SIERRA GEOTECHNICAL SERVICES INC.

Subject: **RESPONSE TO PEER REVIEW**
Phase 2 of Tentative Tract 37-46
White Mountain Estates Subdivision
Chalfant Valley, Mono County, California

Reference: Review Of Earthquake Fault Zone Hazard Evaluation Reports
Tract 37-16 And Phase 2 of Tentative Tract Map No. 37-46
White Mountain Estates Subdivision
Chalfant Valley, Mono County, California
Prepared by AMEC Earth & Environmental dated January 12, 2006

GEOLOGIC LOG OF DEEPENED TRENCH T-10
SHEETS 1 – 4 OF 4

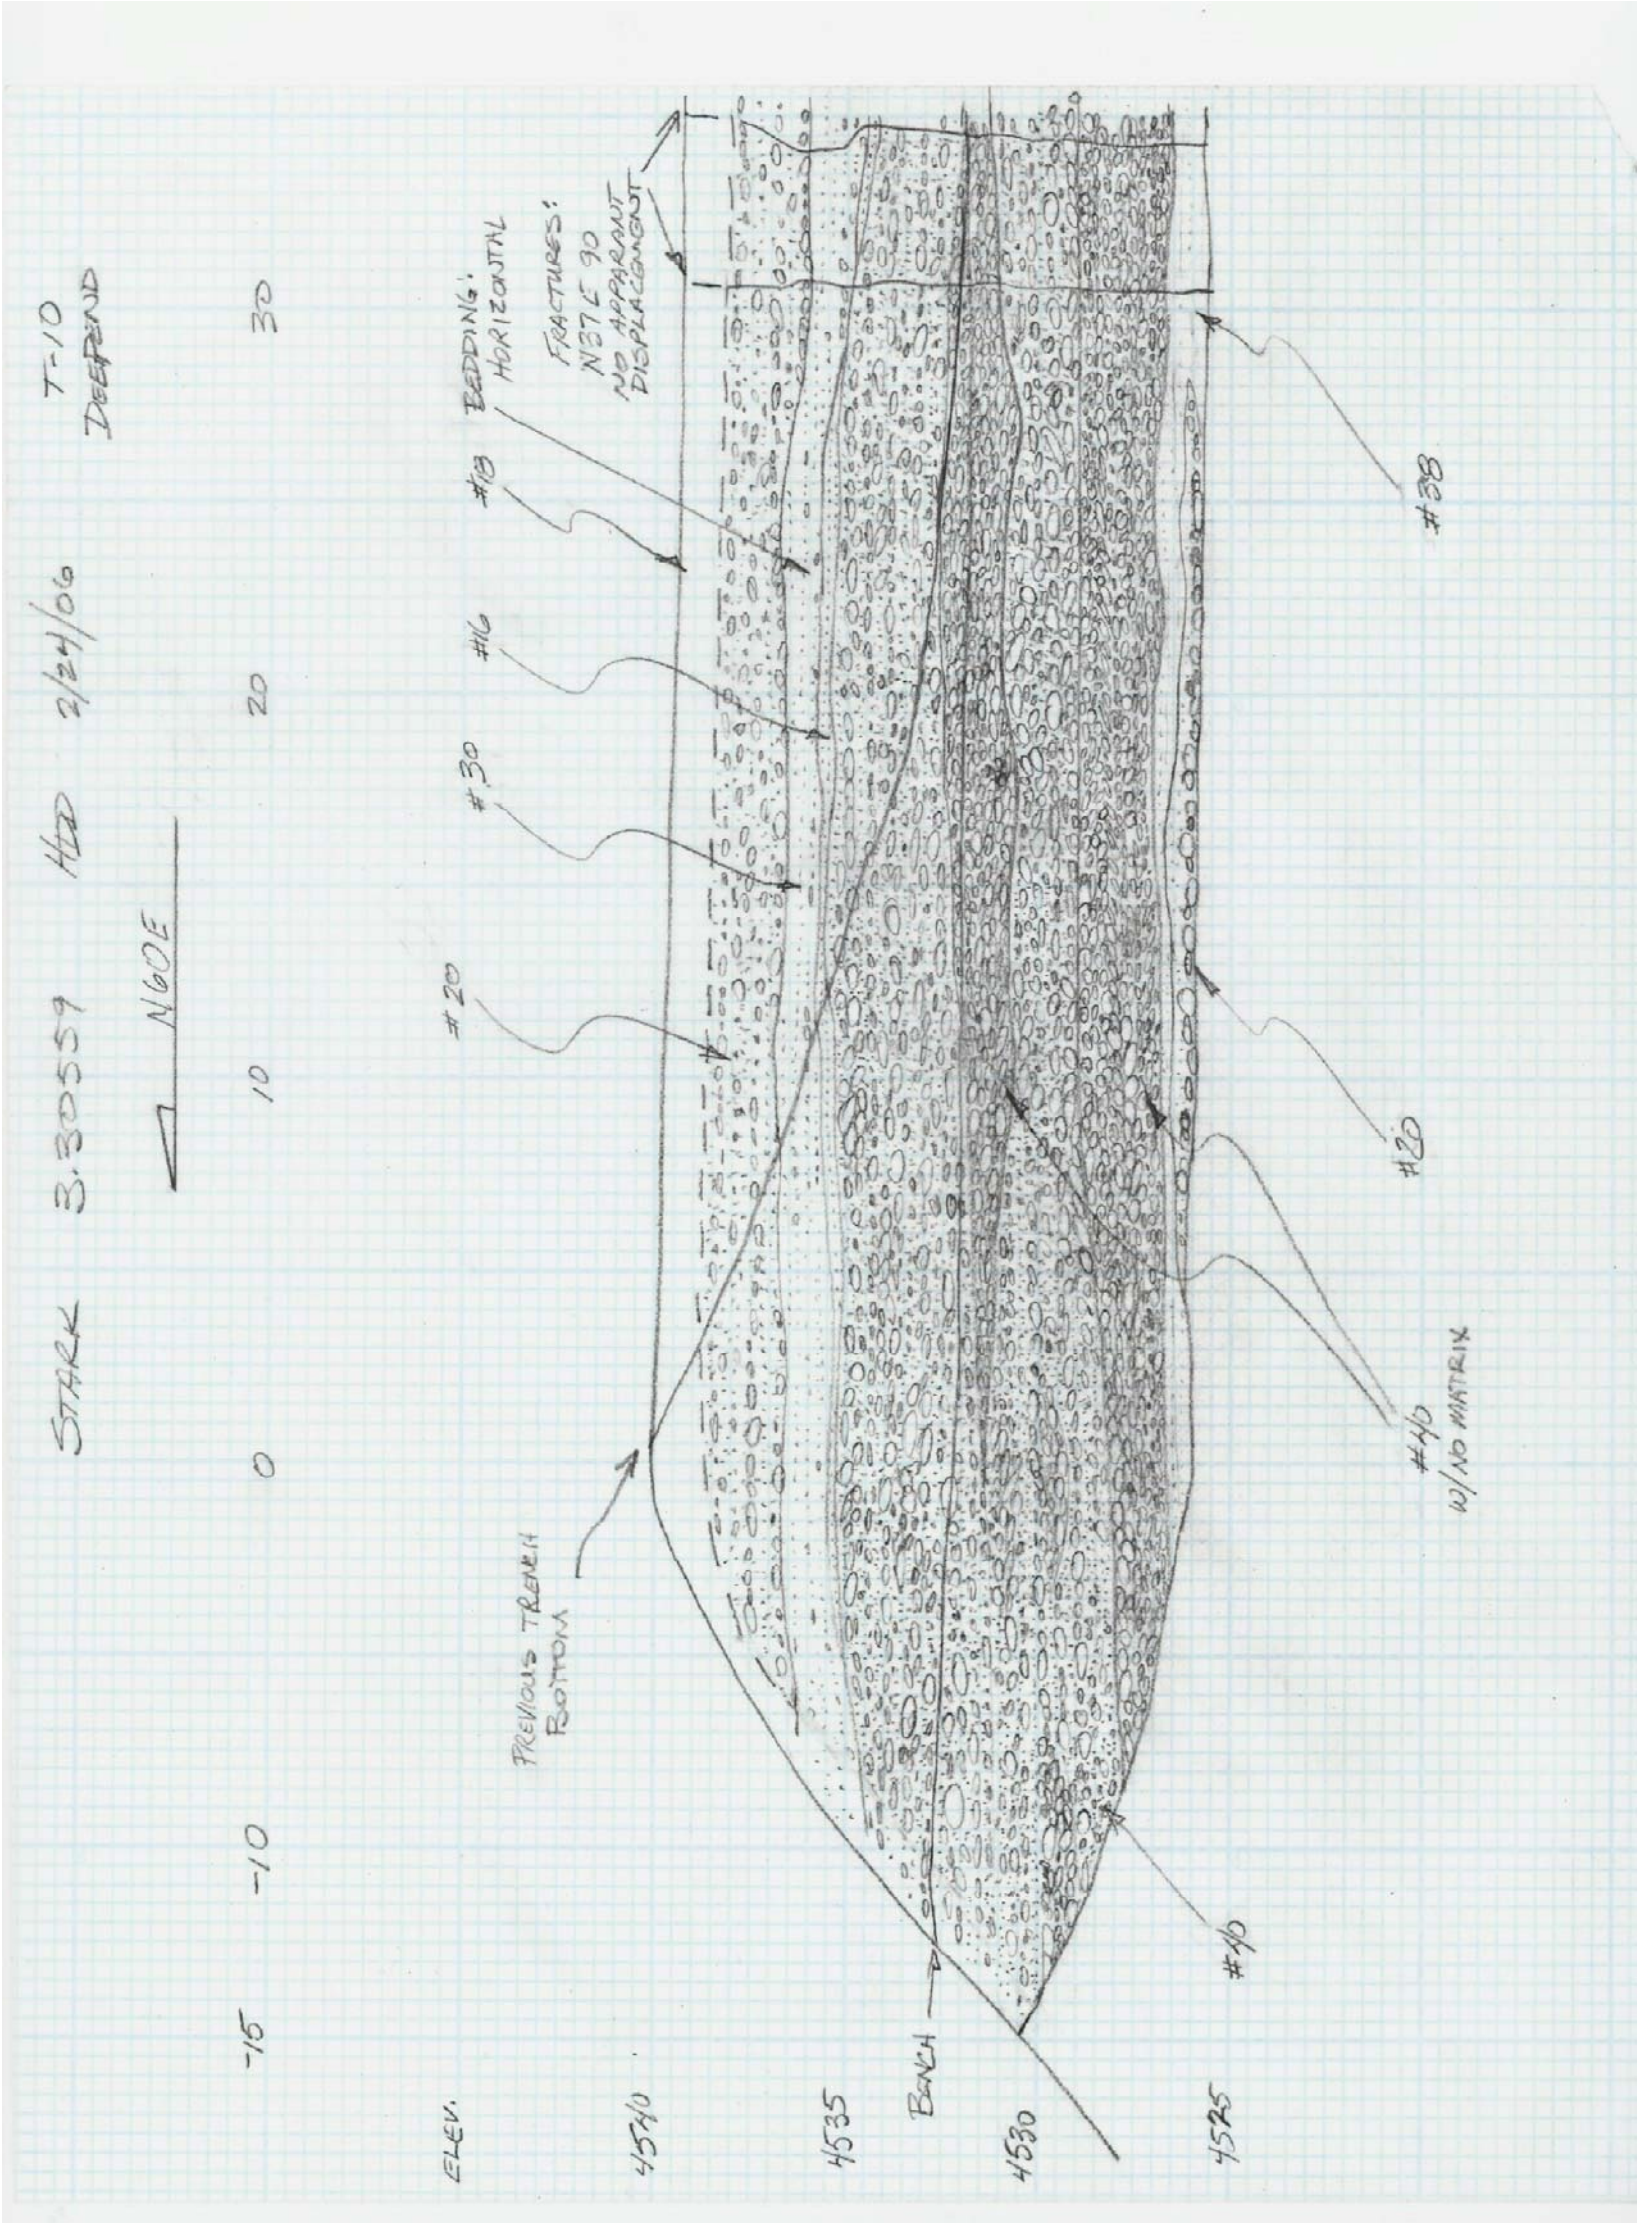
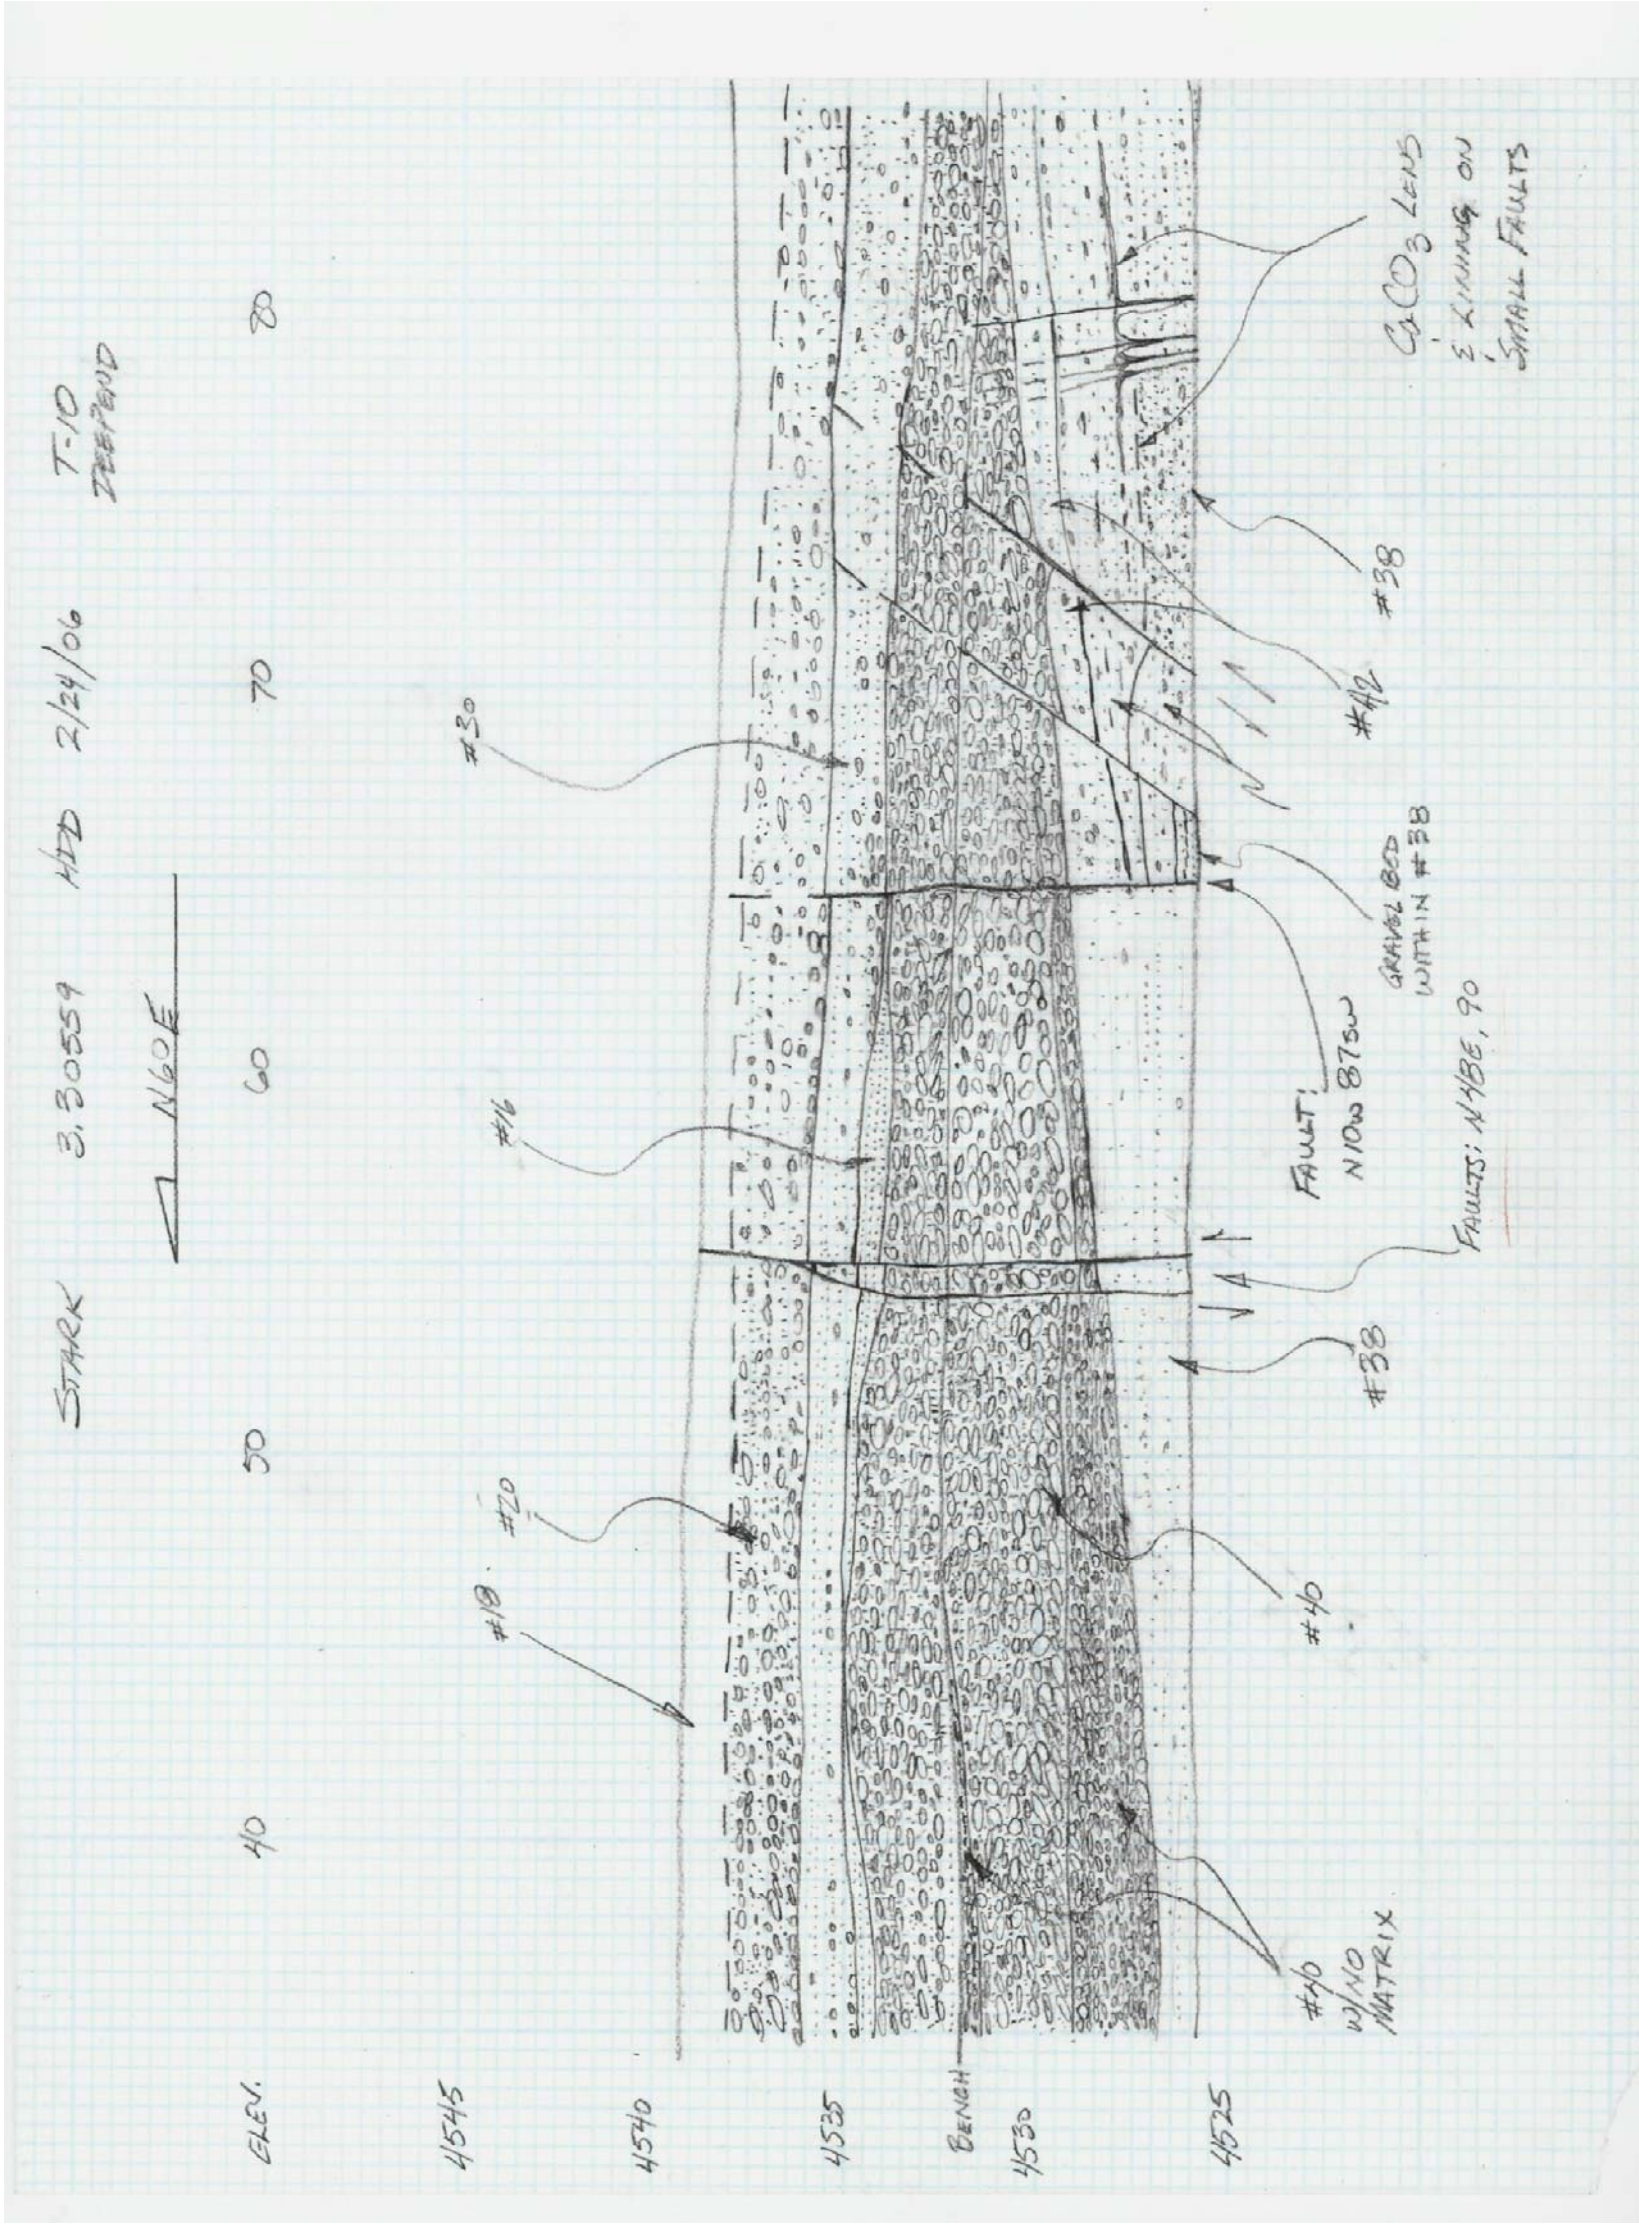
The designated habitable area within Lot 46 is based on the fault related features and their structural orientations as observed and subsequently depicted in the log of Trenches T-10. The geomorphic features mapped within Lot 46 have been designated as Qfo (6), Qfo (7) having respective ages varying from 200,000 to more than a million years old as previously determined by Bruce Schell. The alluvial sediments exposed in the fault Trench T-10 is described by SGSI as being recent to late Pleistocene in age. The designated habitable area within Lot 46 is depicted as an irregular shaped area approximately 250 feet long and 140 [feet] wide.

The westerly portion of Trench T-10 from Station 0+00 to 1+20 is underlain by recent alluvial deposits. The contact base of the Holocene sediments has not been exposed within this portion of Trench T-10 and as such a definitive statement regarding the active faulting cannot be made by the project consultant within this portion of the proposed habitable area. In addition, the attitude of fractures noted cutting through the recent deposits are similar to the orientation of the crossing faults observed in Trench T-2 and T-6. Based on these conditions it is recommended that the proposed habitable area associated with the westerly portion of Trench T-5 not be accepted without deepening of the trench to expose the full section of Holocene alluvial fan deposits, from the contact with the underlying Pleistocene alluvium to the ground surface, that are unaffected by fault related features.

Response: In conformance with the recommendation provided in the comment above, Trench T-10 was re-trenched to expose the full section of the Holocene alluvial fan from the ground surface down to its contact with the underlying older Pleistocene alluvium. Based upon our observations and logging of the deepened exposure, active faulting was observed from Stations 0+50 through 1+10. This find is consistent with tonal lineaments previously observed in our aerial photographic review and with the southward projecting faults found in Trench T-6 to the north. Therefore, the proposed habitable area within Lot 46 is hereby completely removed.
